COUNTY OF SAN MATEO PLANNING AND BUILDING

SUBJECT: Coastside Design Review Recommendation

Columbus Street, El Granada

APN 047-275-060; County File No. PLN 2017-00002

FLOOR PLANS

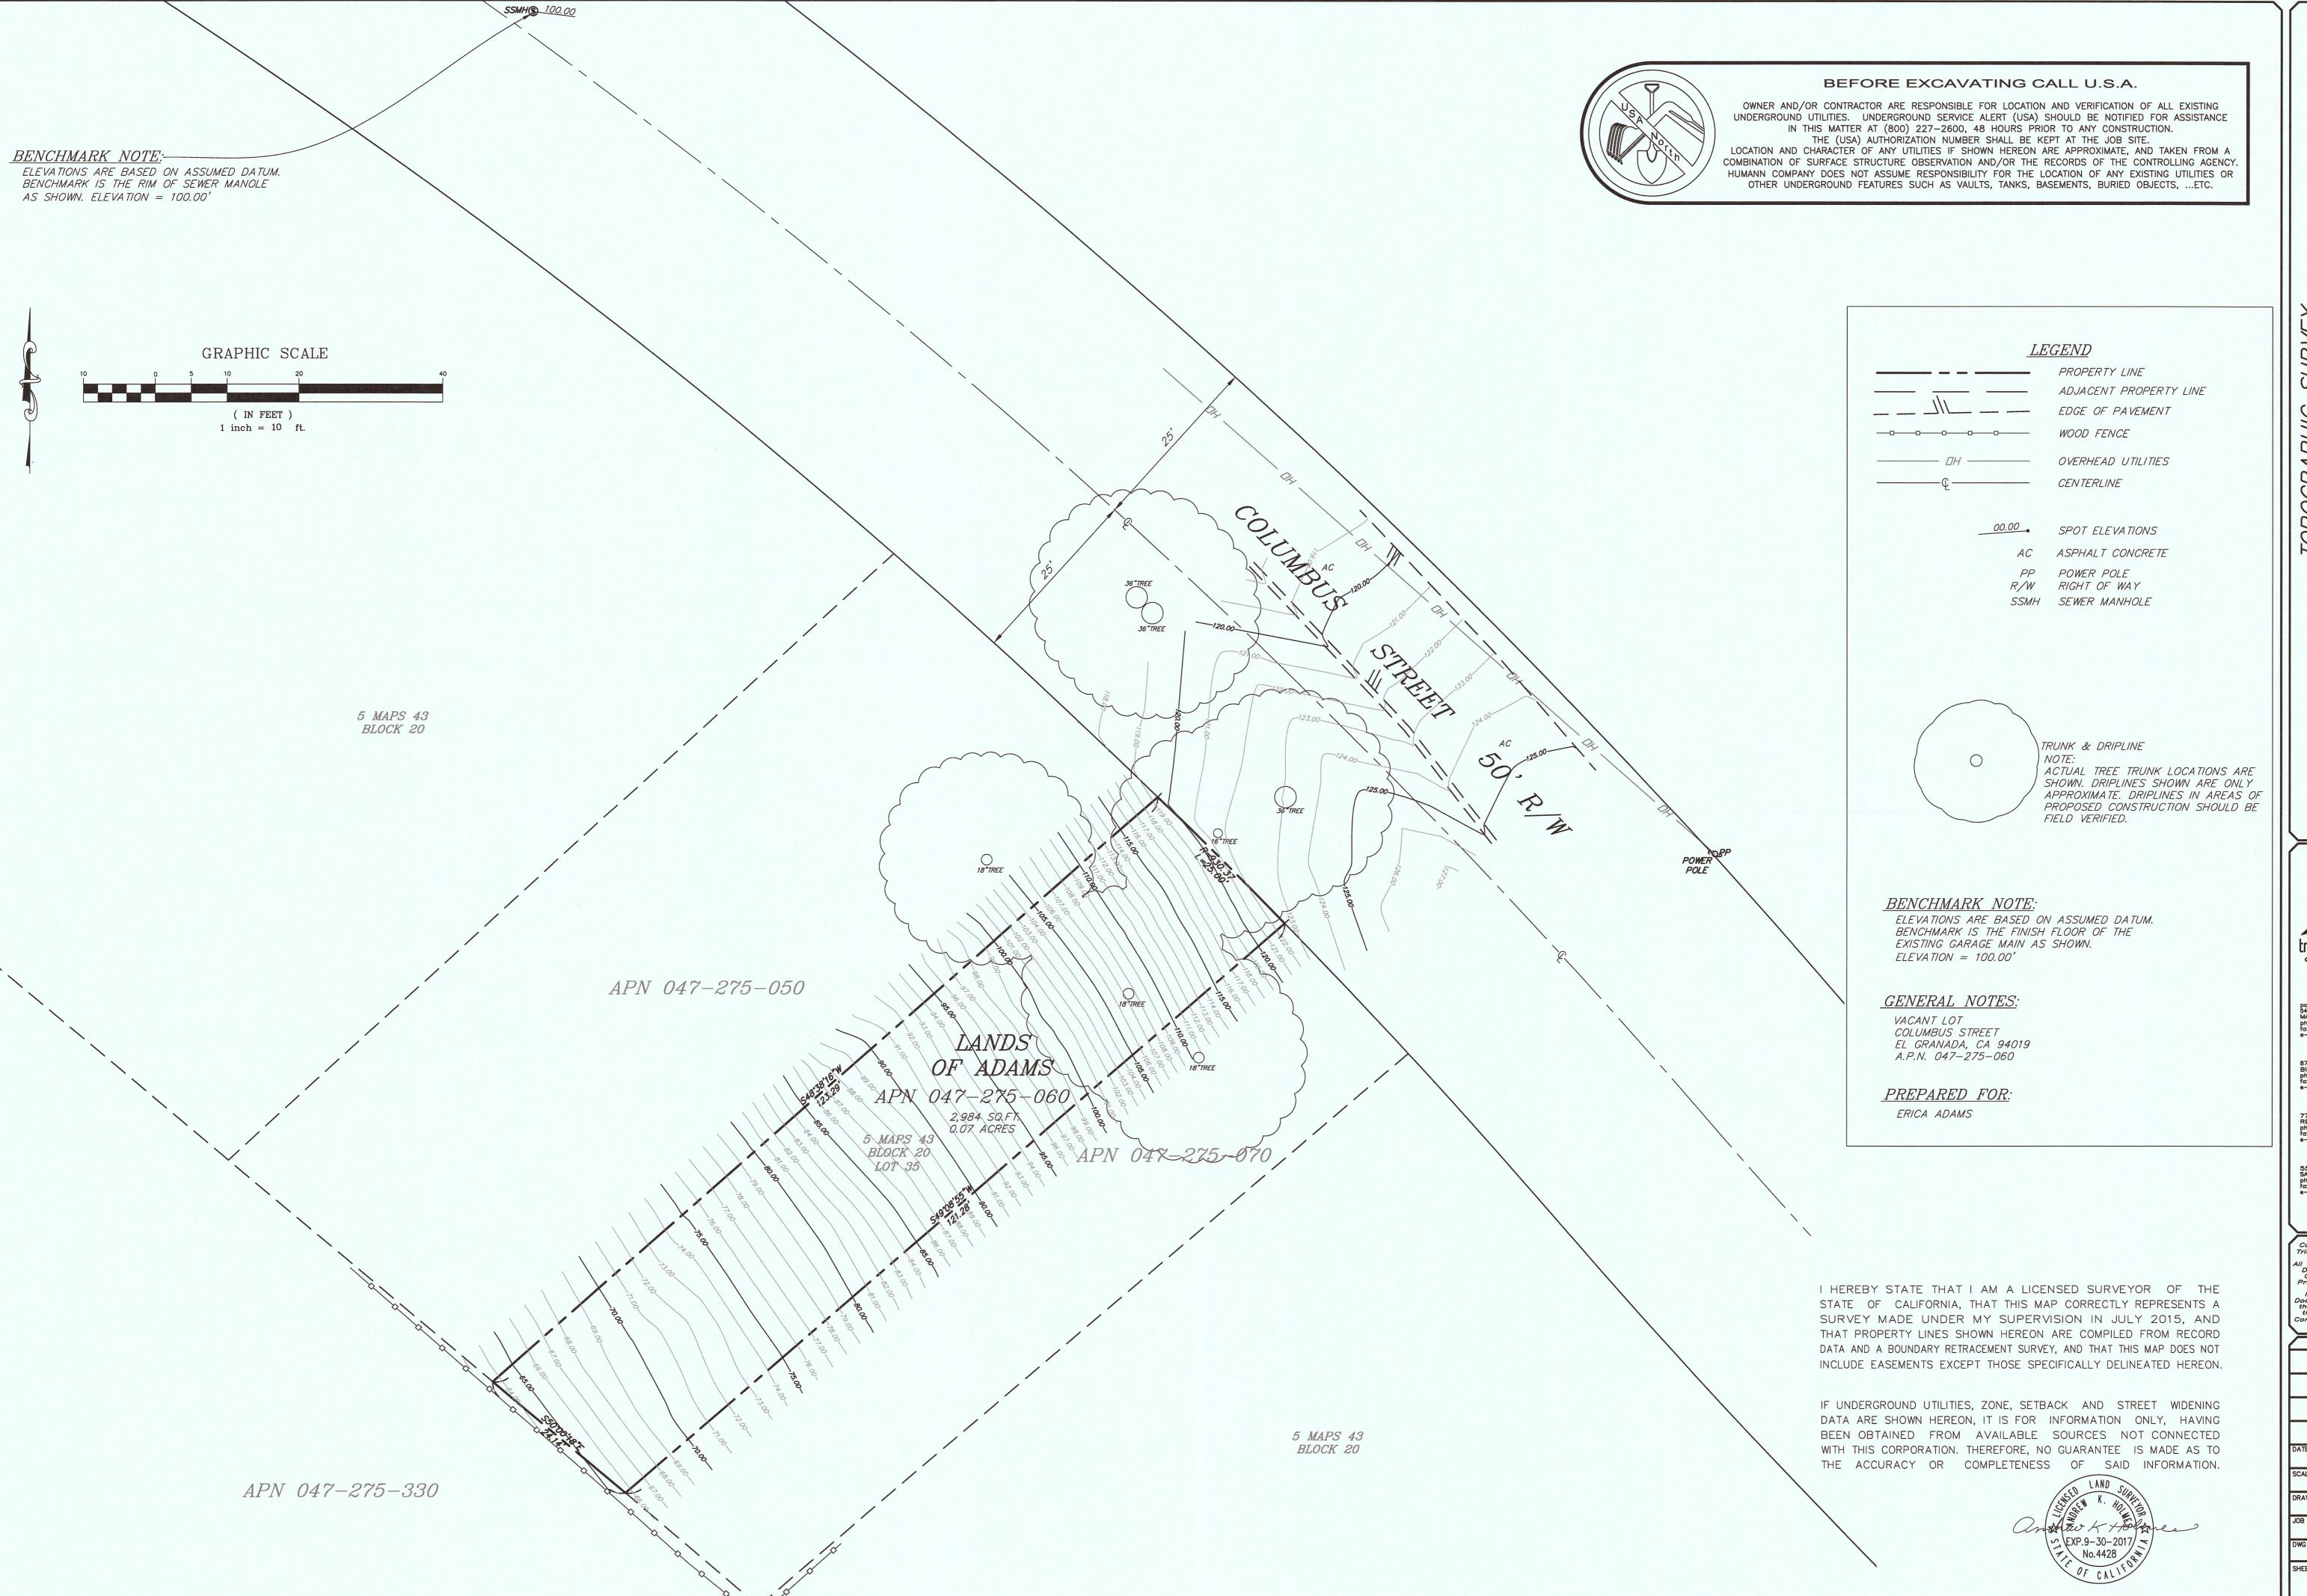
- c. Section 6565.20(D). ELEMENTS OF DESIGN; 1. Building Mass, Shape and Scale; a. Relationship to Existing Topography; Standards (2) and (3): Increase the terracing of balconies with regard to their relationship to the topography of the site. Minimize the unused space under the lower level and middle level of the house.

- d. Section 6565.20(D). ELEMENTS OF DESIGN; 2. Architectural Styles and Features; d. Garages; Standard (1): Modify the garage design to minimize the prominence of the garage as viewed from the street, and articulate the front entry elevation.
